ITEM NO 2
MEETING DATE May 14, 2014
STAFF Holland
HEARING OFFICER

STAFF REPORT

PROJECT: Plum and Shields Extra Occupancy Rental House, PDP #130053 and Modifications of Standard to Sections 3.2.2(J) and 3.2.2(L) Table A.

PAVING PLAN

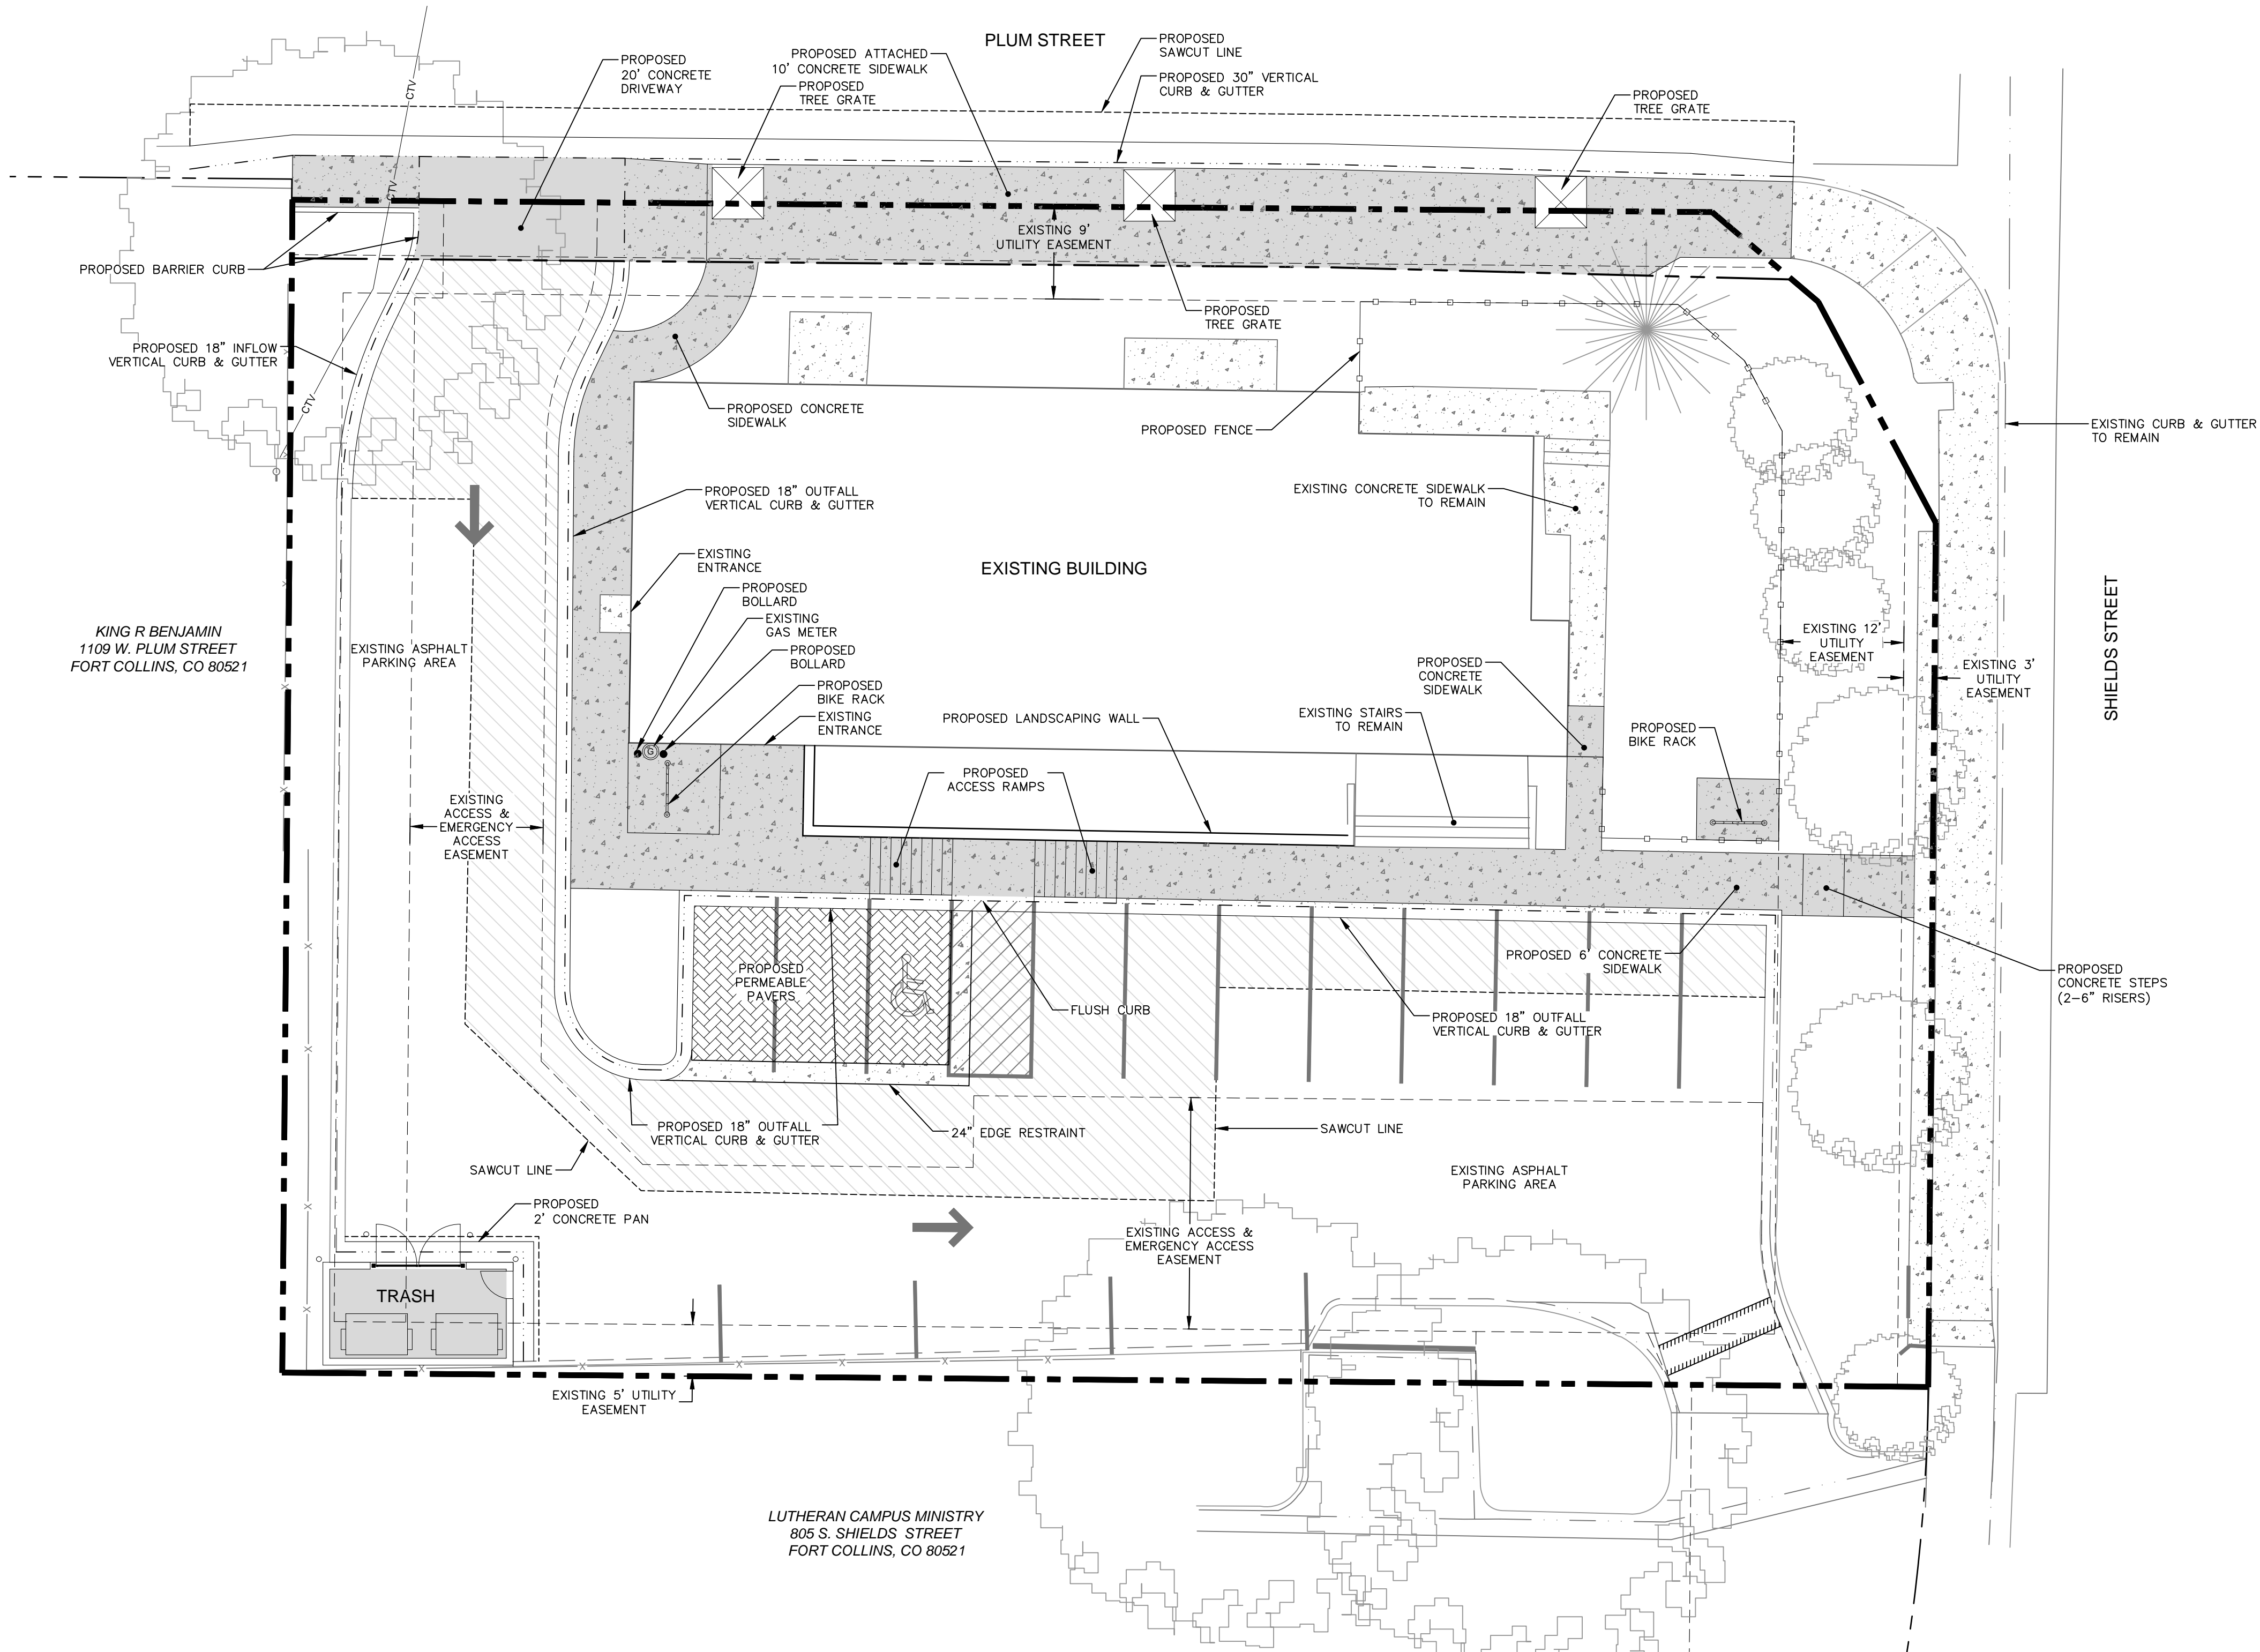
The applicant has submitted a request for approval of a Modification of Standard to *Section 3.2.2(L), Table A Standard Vehicle Dimensions* to permit a two-way drive aisle width of 18.6 feet instead of 24 feet.

- The parking area as modified provides off-street parking, which is desirable. The off-street spaces help reduce on-street parking, therefore providing a benefit to the adjacent neighborhoods.*
- The intent of the 24' wide drive aisle width is to allow cars to have ample room to back out of a parking space. We feel that, although not ideal, the benefits of the parking stalls outweigh the inconvenience of having a narrower drive aisle."*

Staff finds that the request for the Modification of Standard to *Section 3.2.2(L), Table A Standard Vehicle Dimensions* is justified by the applicable standards in 2.8.2(H). The granting of the Modifications would not be detrimental to the public good and:

The request satisfies Criteria 2.8.2(H)(4) because the project accommodates a new sidewalk that is 6 feet in width, new landscaping along the building facade and new parking stalls that meet the dimensional requirements, and that the reduced drive isle width is nominal and allows a better overall configuration of site plan elements. The overall plan is consistent with the policies of the Land Use Code described in Section 1.2.2 by:
